UNITED STATES PATENT AND TRADEMARK OFFICE

Office Action Summary

10/604,233

DETAILED ACTION

Fig. 2

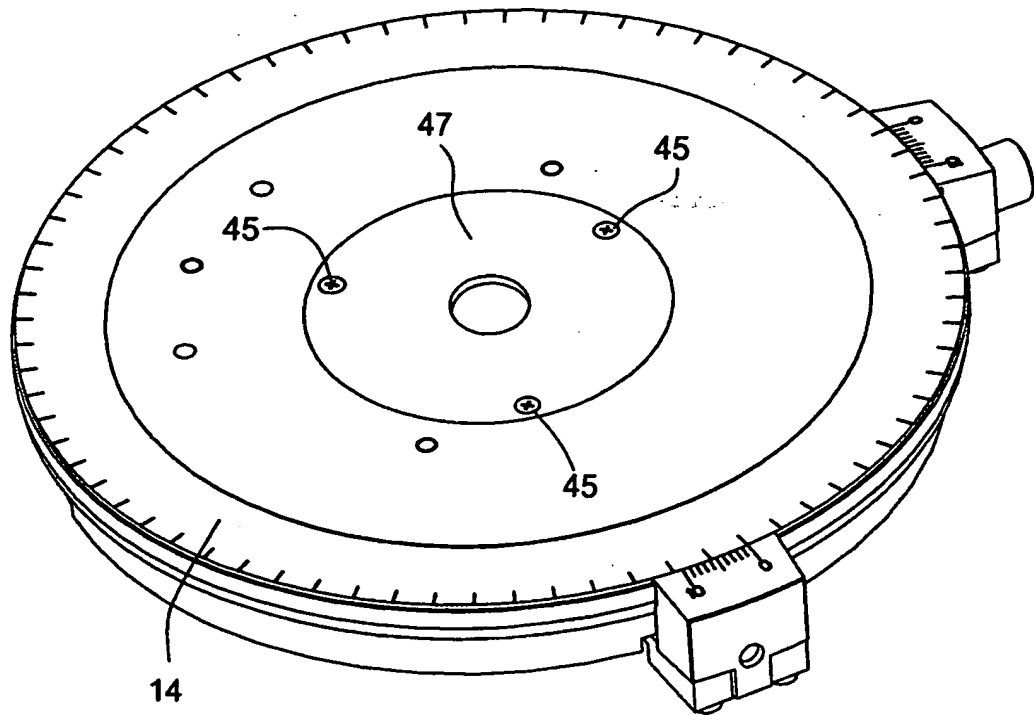
2. The drawing contained corrected fig. 2 was received on 2/16/05. The corrected drawing is approved by the Examiner.
